MOSCA Middleton on Sea Coastal Alliance

**Written Representation to the Rampion 2 Examination Authority
(ExA) on the Development Consent Order (DCO) Application**

**Important Issues underlining: Seascape, Landscape and Visual
Impacts**

Submission date: 28 February 2024

The illustration below shows a direct comparison between both Rampion1 (140mtrs.) and Rampion2 (325mtrs.) turbines against The Spinnaker tower and Eiffel Tower.¹

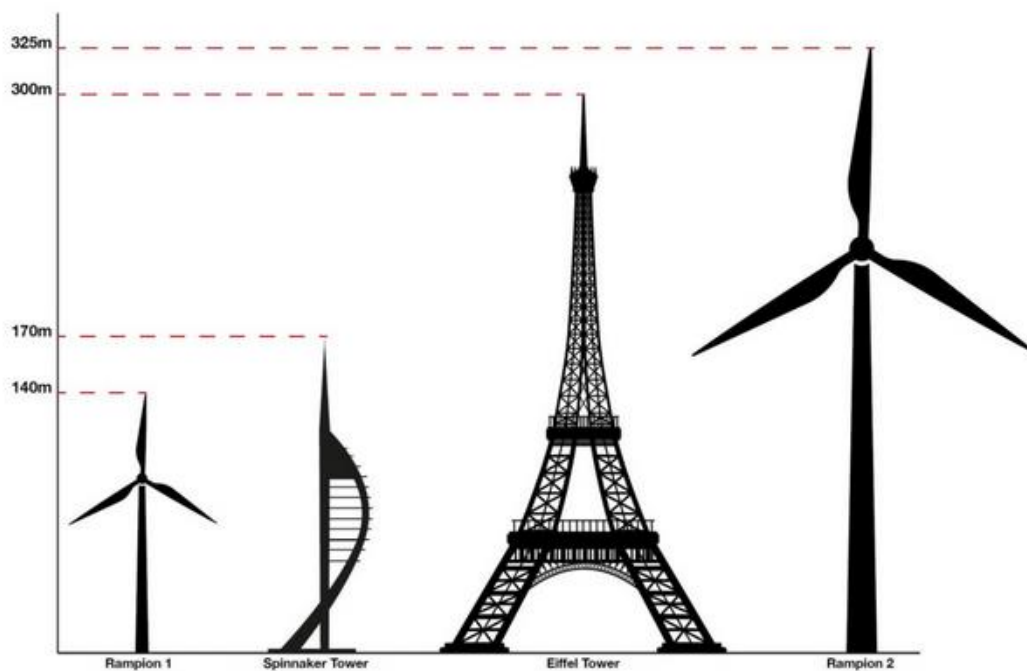
NB: The turbines will be higher than the 310mtr Shard building in London – up to 90 of them – Imagine this infrastructure development side by side or sporadically placed along the Thames!
